ATTN: Document Control Desk
U. S. Nuclear Regulatory Commission
Washington, DC 20555-0001**SUBJECT:**Beaver Valley Power Station, Unit Nos. 1 and 2
BVPS-1 Docket No. 50-334, License No. DPR-66
BVPS-2 Docket No. 50-412, License No. NPF-73
Supplemental Response to Generic Letter 2004-02 (TAC Nos. MC4665 and MC4666)

Supplemental Response to Generic Letter 2004-02
for Beaver Valley Power Station Unit No. 1 and Unit No. 2
Page 1 of 208

Figure 3.e-2

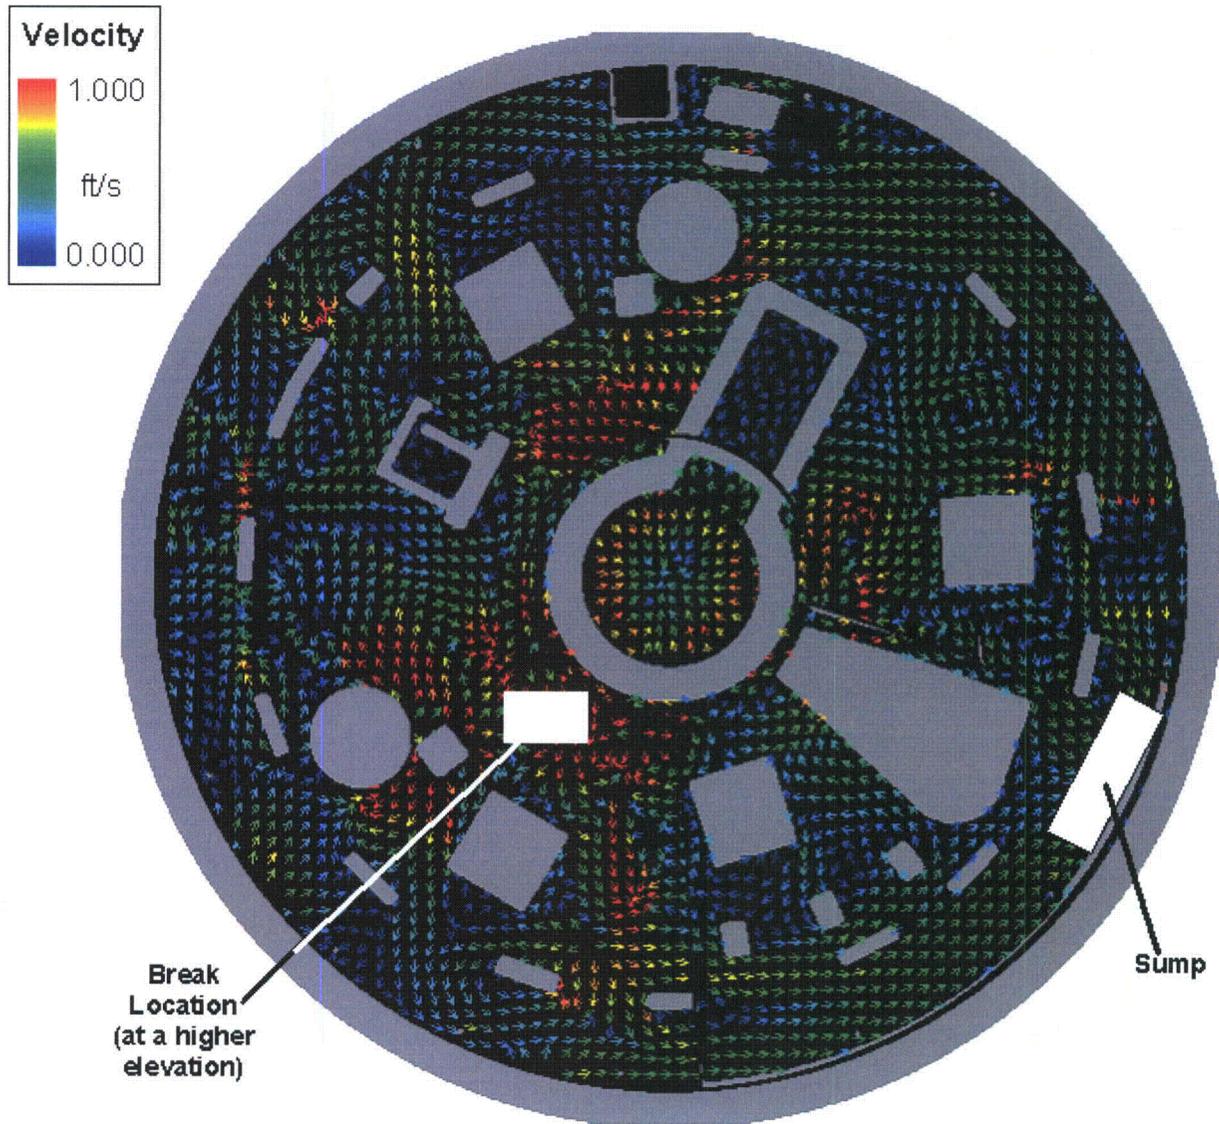
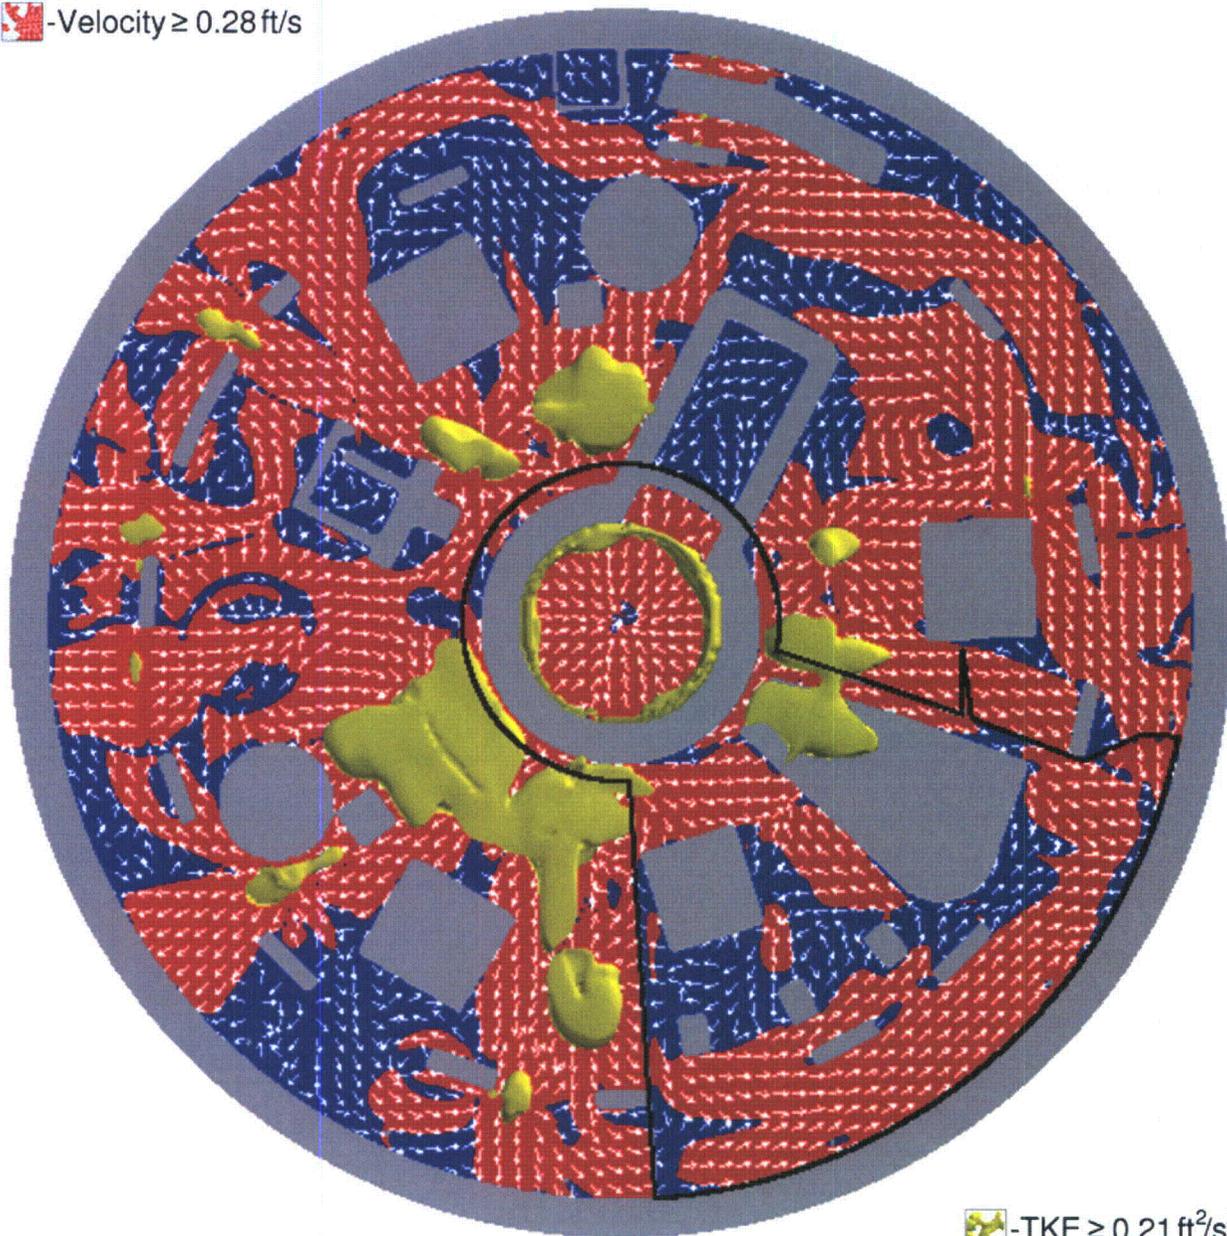
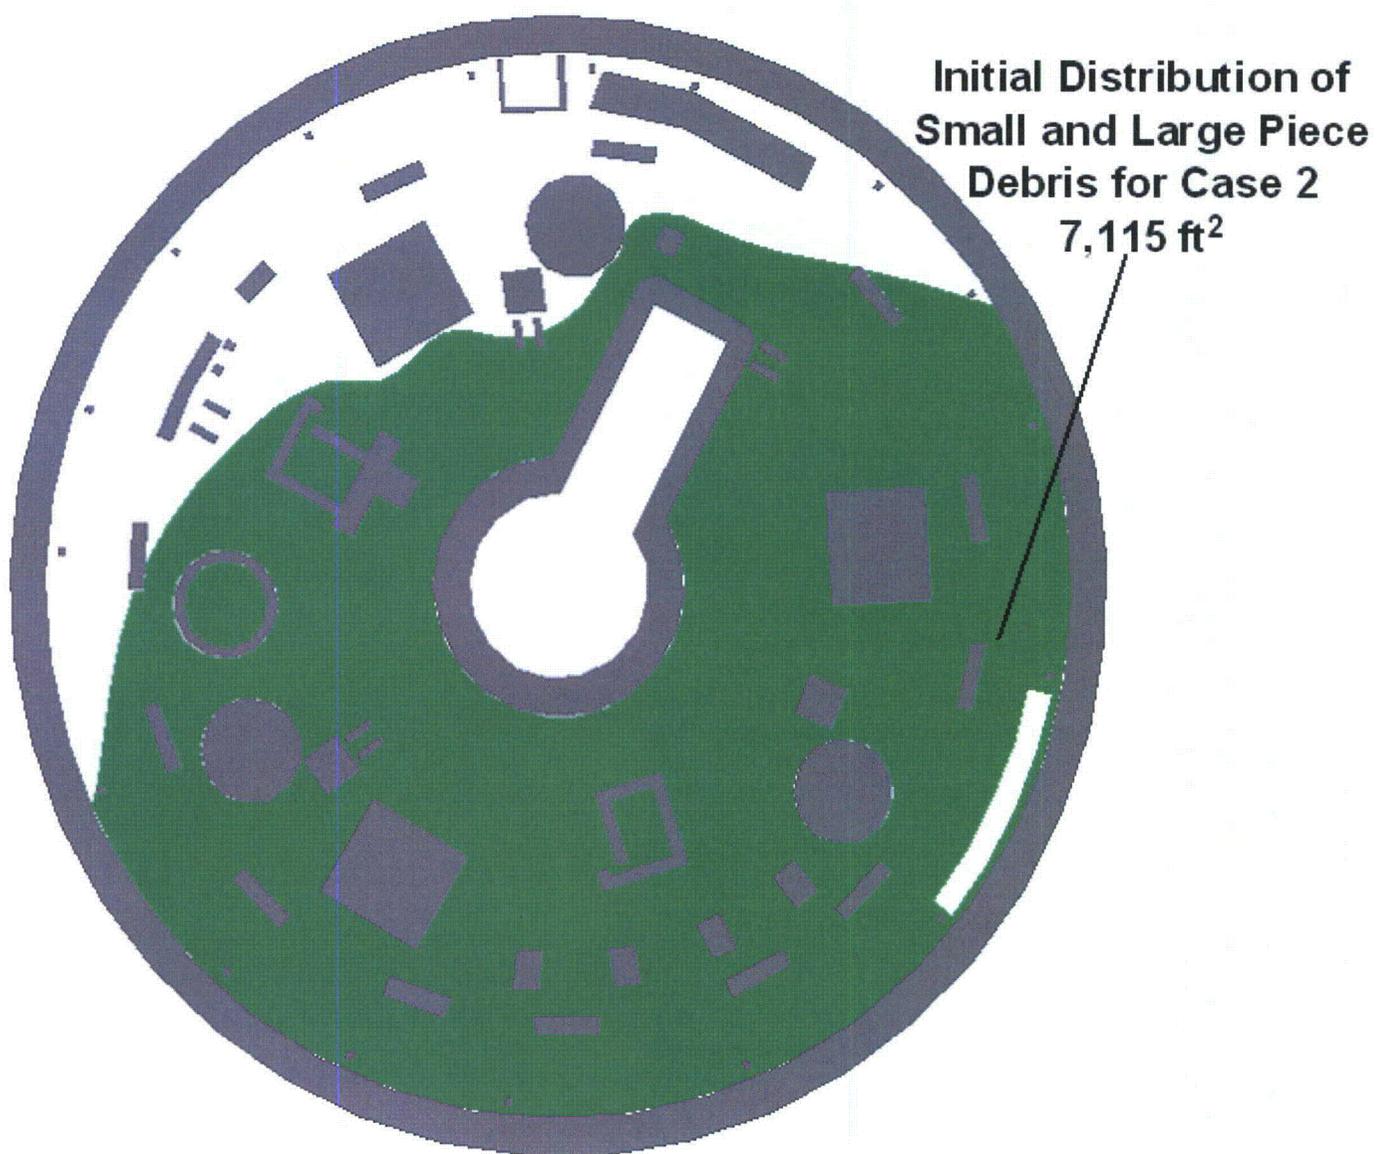
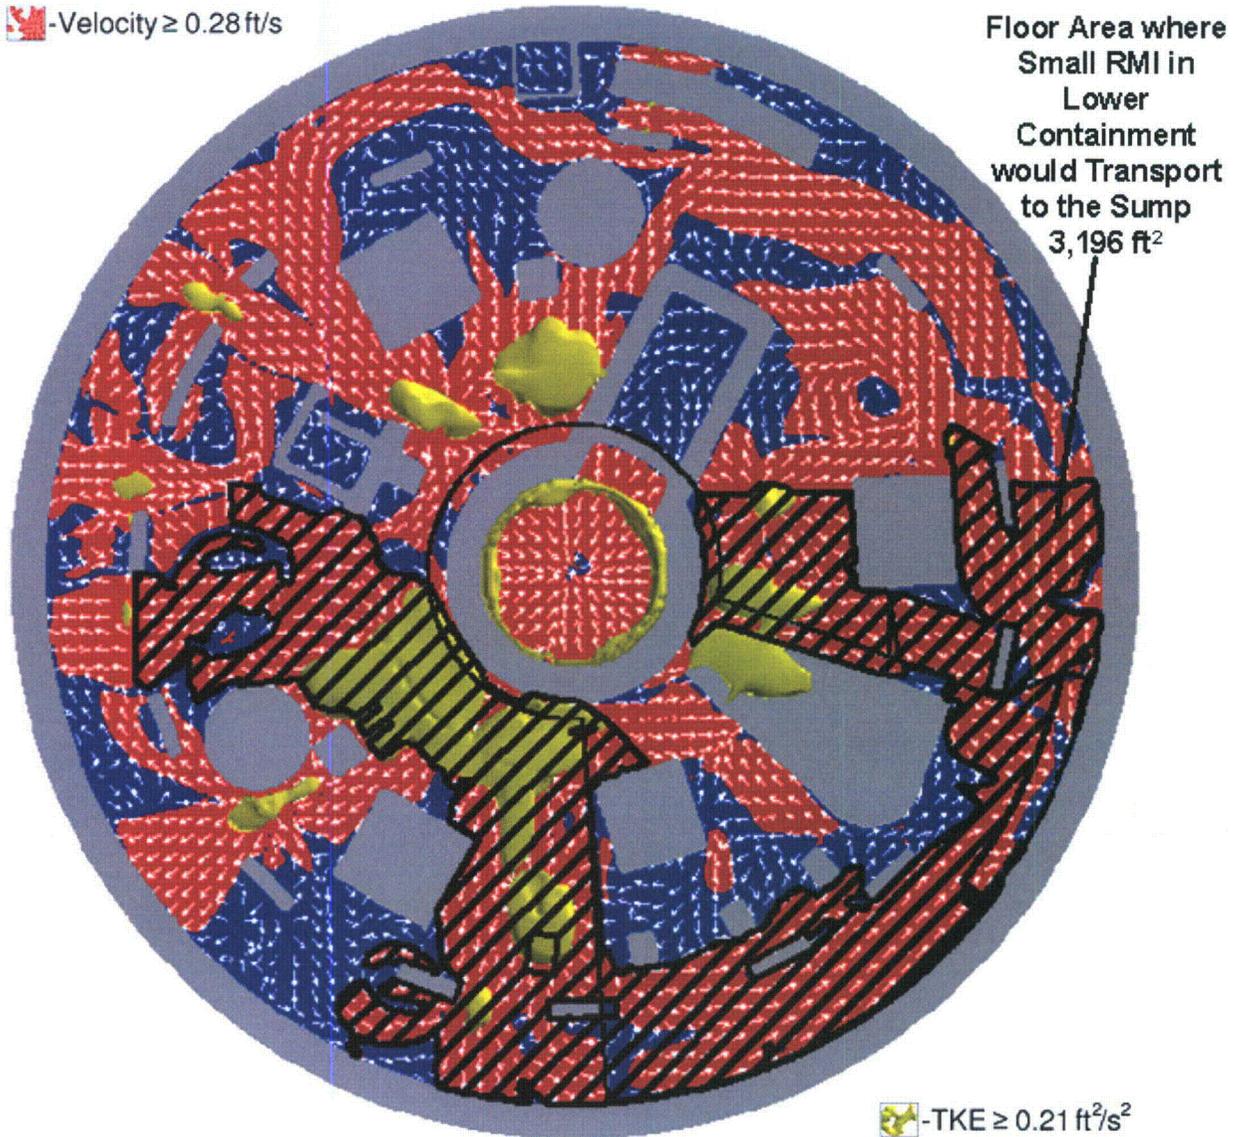
The following figures (Figure 3.e-2, 3.e-3, 3.e-4, and 3.e-5) and discussion are presented as an example of how the transport analysis was performed for a single debris type at BVPS-1 – Small Piece Stainless Steel RMI. This same approach was utilized for other debris types analyzed at BVPS-1.

Figure 3.e-3 shows that the turbulence in the pool is not high enough to suspend small RMI debris essentially anywhere in the pool. Therefore, the tumbling velocity is considered to be the predominant means of transport. The small RMI debris not blown to upper containment was assumed initially to be uniformly distributed between the location where it was destroyed and the sump screen, as shown in Figure 3.e-4. This area was overlaid on top of the plot showing the tumbling velocity and flow vectors to determine the recirculation transport fraction. The area where small pieces of RMI would transport within the initial distribution area is 3,196 square feet as shown in Figure 3.e-5. Since the initial distribution area was determined to be 7,115 square feet, the recirculation transport fraction for small pieces of RMI is 45 percent.
